## **Addendum No. 1**

**RFP 08-10350-3618**

### **Roadway and Campus Fiber Installation Services for Uniontown to Brownsville Phase I**

DRAWING TO CLARIFY MAINLINE INTERCHANGE M-19 TO REDSTONE TOWER - CONDUIT AND JB LAYOUTS

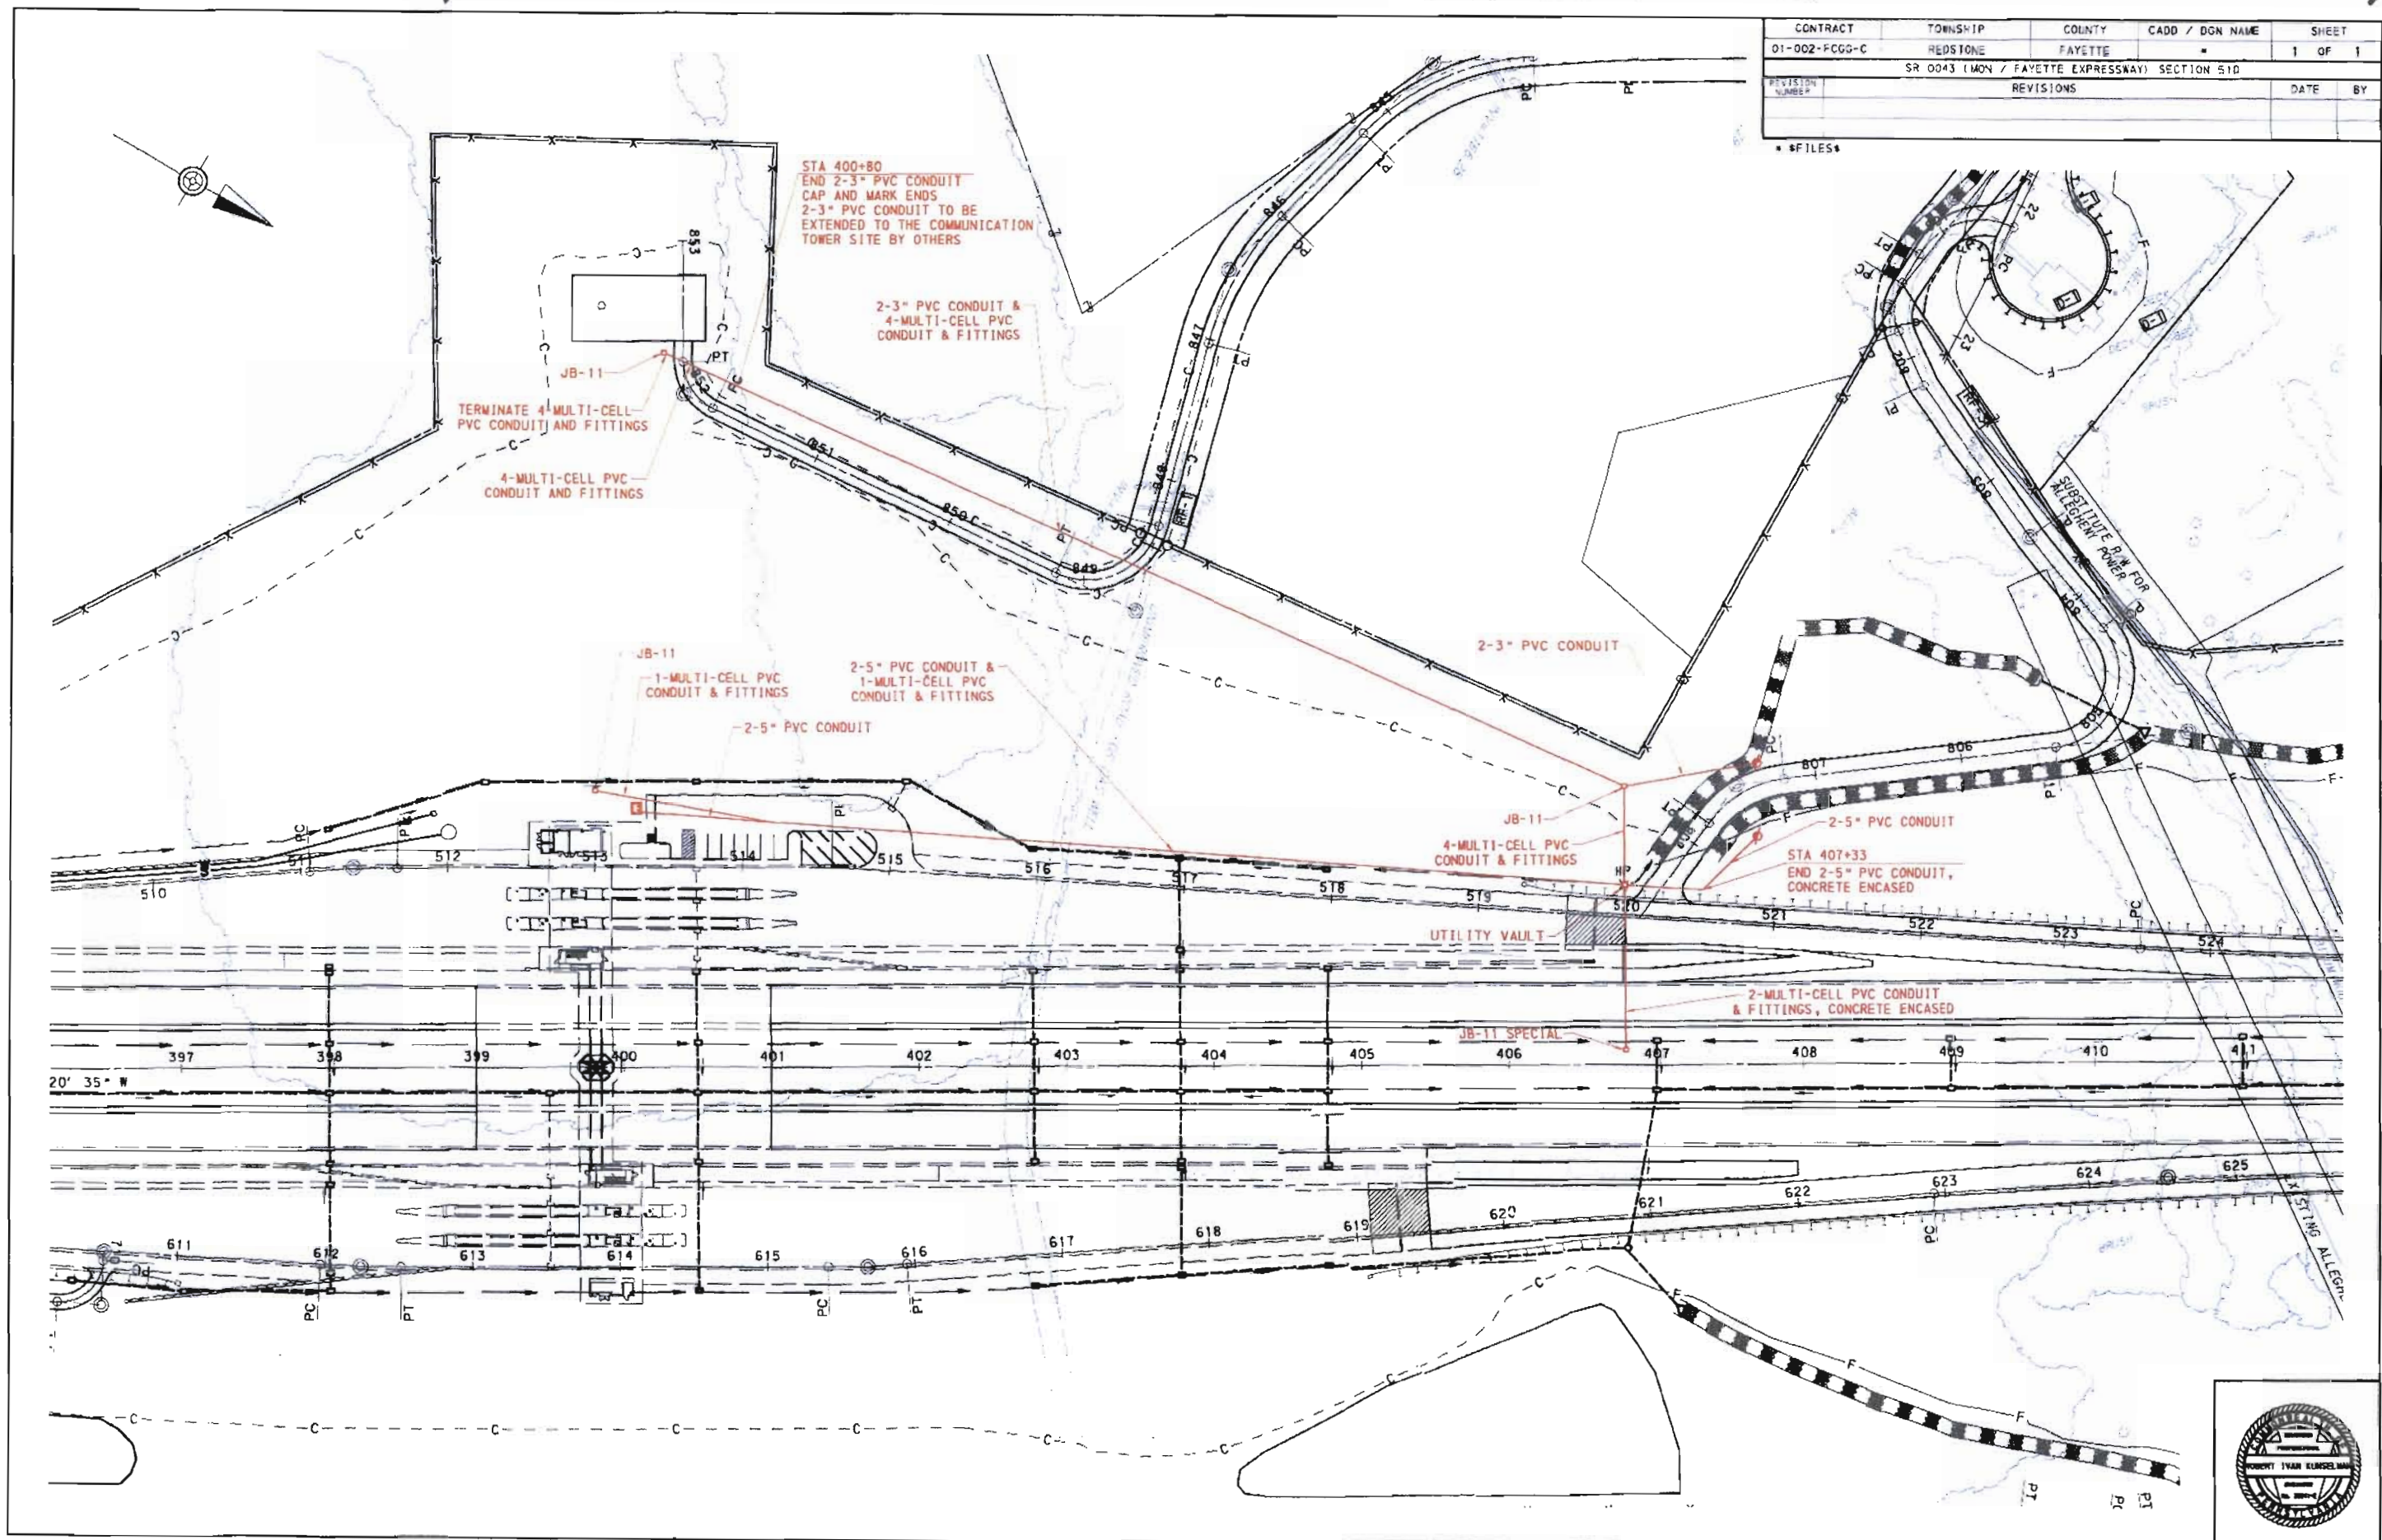
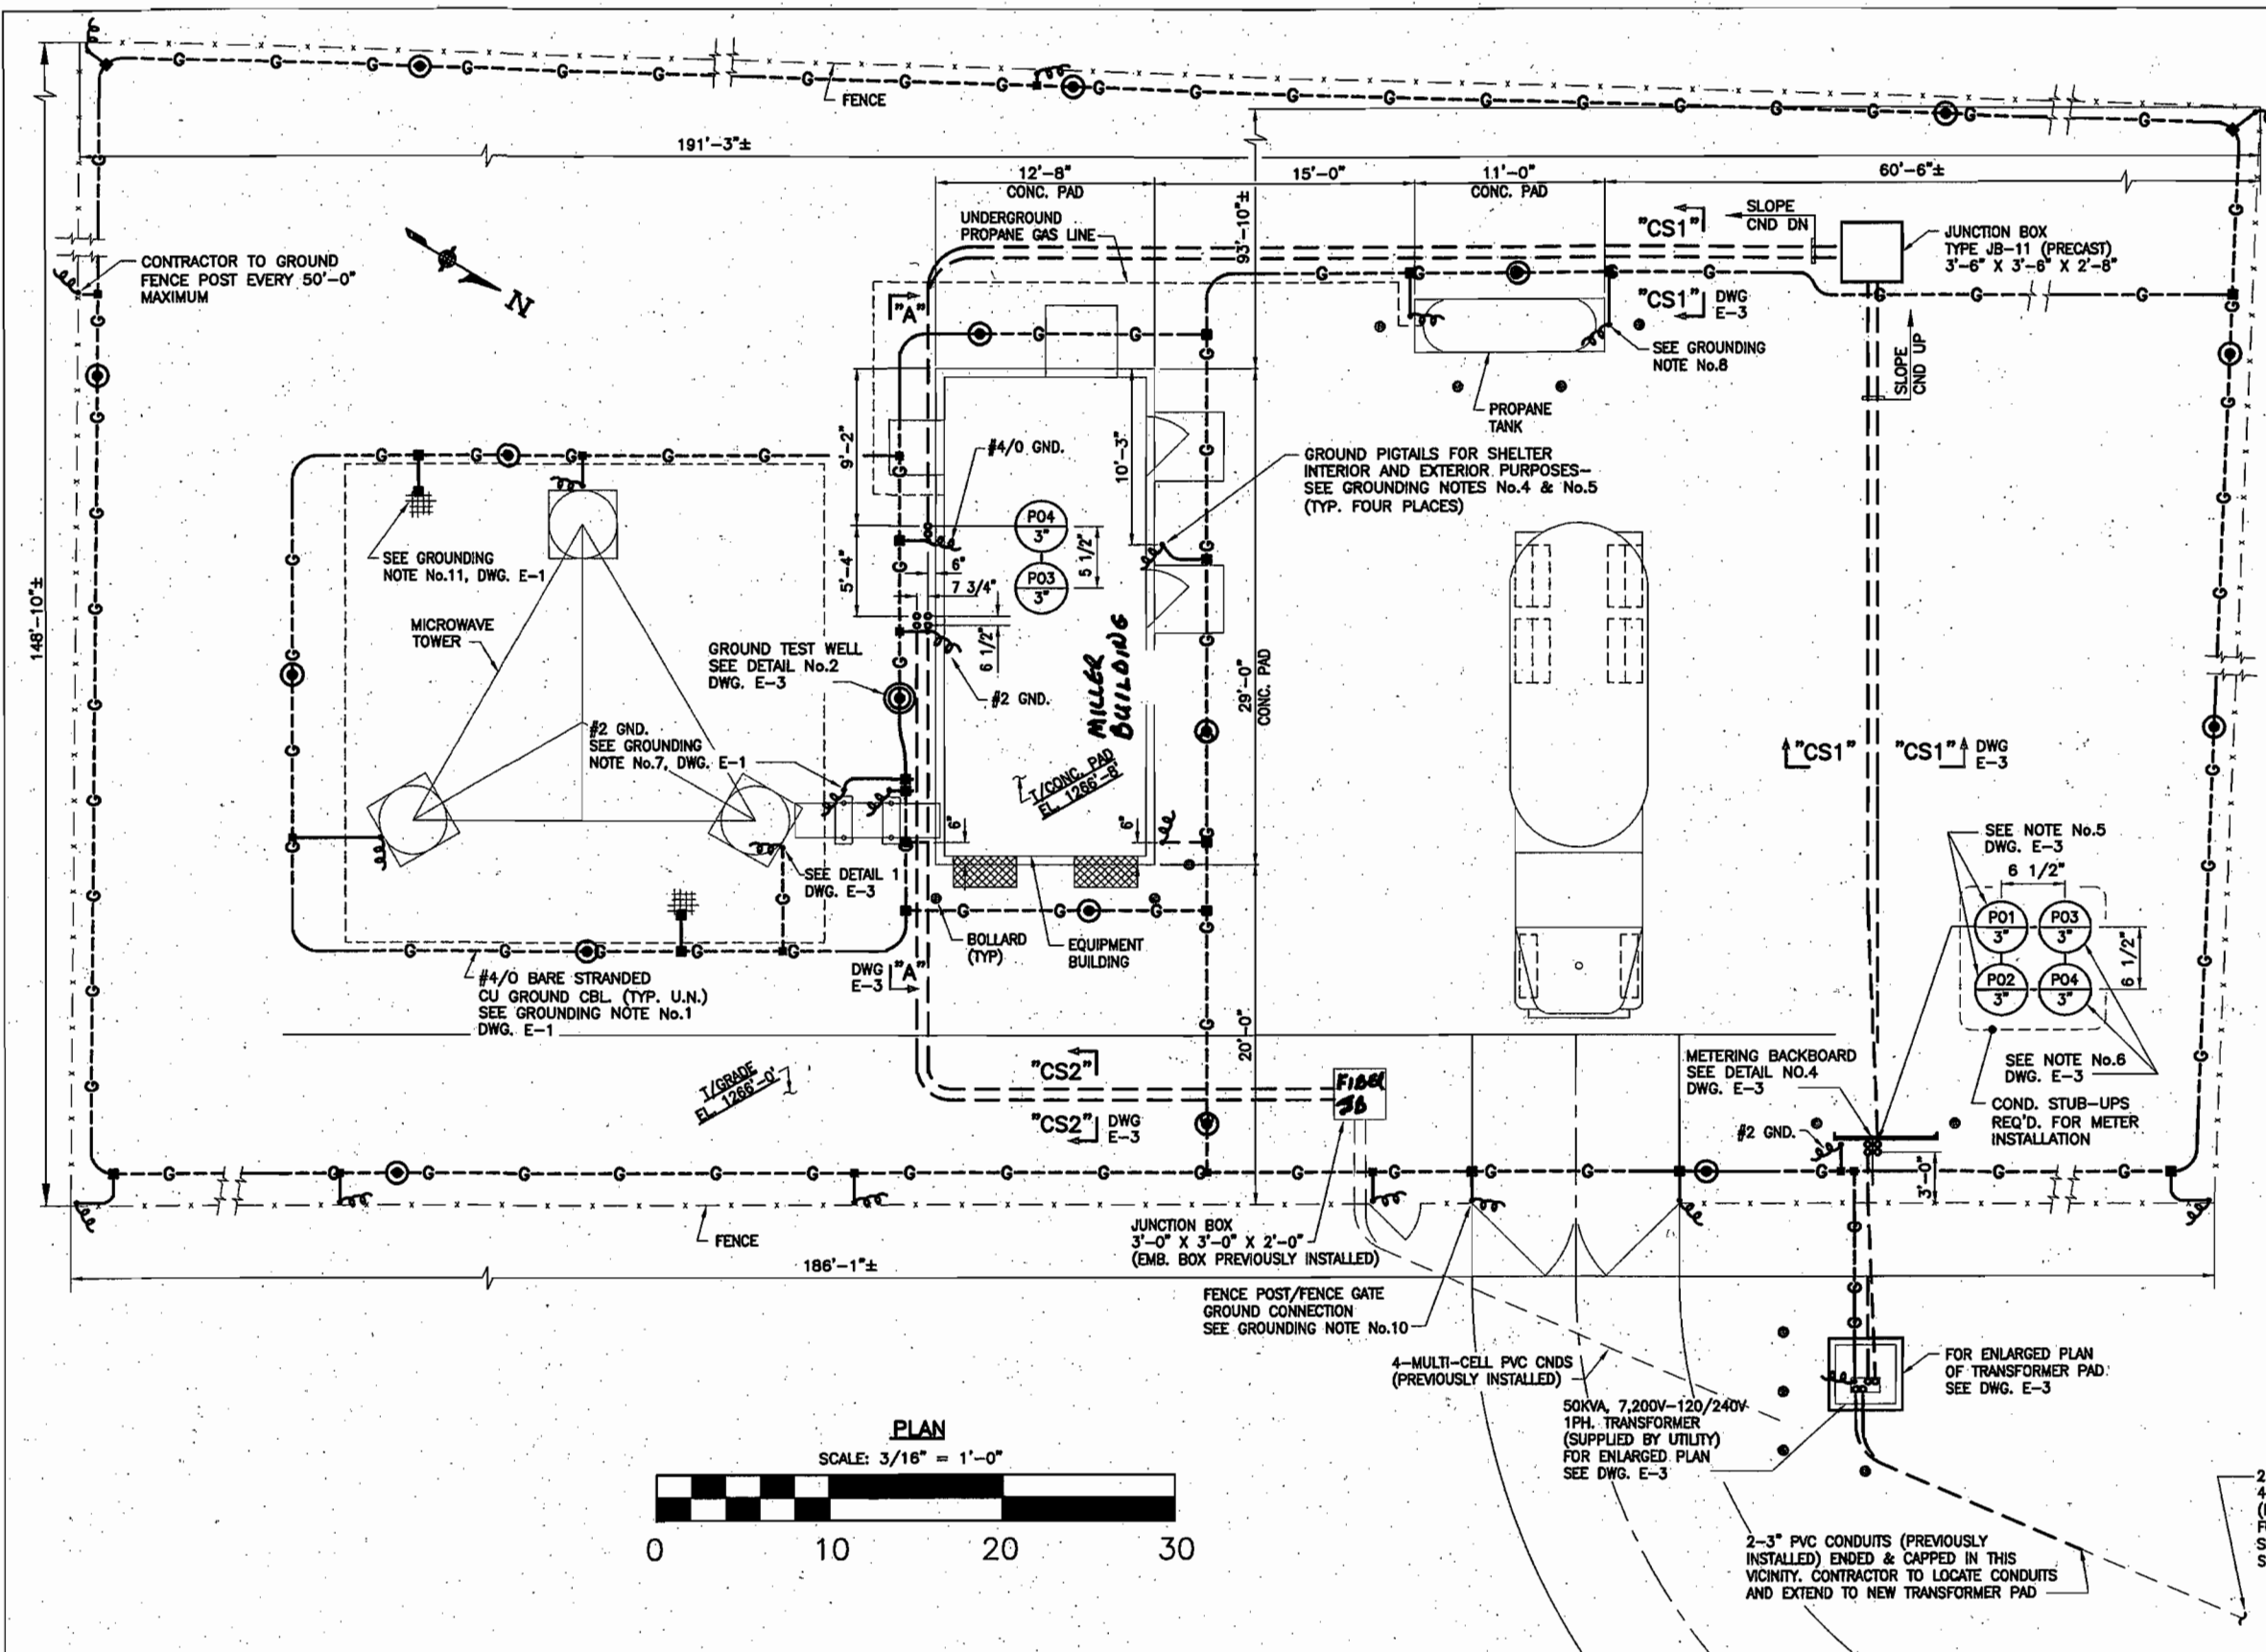
**This drawing will provide a better view of the multi-duct conduit layout up to the Redstone Tower site, specifically at the location where it crosses from the mainline median area and goes up the hill to the tower.**

**The duct crosses from a JB-11 in the median at approx station 407+20 and goes to a JB-11 up on the hillside near the right-of-way fence. Between these two JB-11's is a utility vault that the conduits go through. The vault is accessible through a manhole lid and is located at the bottom of the hill in the swale area just off of the shoulder. We saw this manhole during the site visit, but it was not obvious that it was part of the raceway system. The conduits run over to the mainline toll facility from this vault and not from the JB-11 by the fence.**
